LAND NORTH-EAST OF JUNCTION 10 M42, NORTH WARWICKSHIRE

Environmental Impact Assessment: Addendum to
Environmental Statement

NWBC Planning Application Ref: PAP/2021/0663

PINS Appeal Ref: APP/R3705/W/24/3336295

**ES VOLUME 4, FIGURE 3.1 - PARAMETERS PLAN
- REPLACEMENT FIGURE**

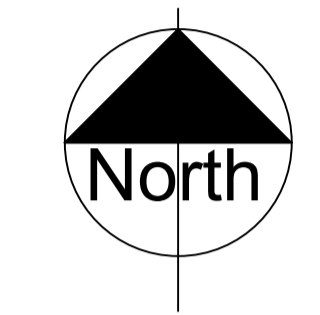
- 1.1.7. An updated Parameters Plan was submitted as part of the application which comprised minor alterations that for completeness should be captured in an ES Addendum.
- 1.1.8. The minor alteration relates to the extent of land required for access (within the red line boundary). The minor alteration in land required had arisen from technical design discussions with National Highways.
- 1.1.9. The plan key in the Parameters Plan was also amended to clarify that the green shaded areas on the Parameters Plan (denoting areas for green infrastructure) also includes (in outline form only at this stage) the potential for on-site connectivity enhancements (including the diversion of the bridleway, footway/cycleways beside the site access road, an off-line shared cycleway, and linkages to the existing footpaths/bridleway). As such, to ensure consistency with the development

parameters stated within the planning application documents, the annotation now reads: “Zone for green infrastructure to include open space, planting, landscaping, site road, *on-site connectivity enhancements* & SuDS” (amendments in red). Please refer to the revised Parameters Plan (ref: 00075 Rev P18) contained at **Enclosure 2** of this Addendum which supersedes the version contained at ES Volume 4: Figure 3.1.
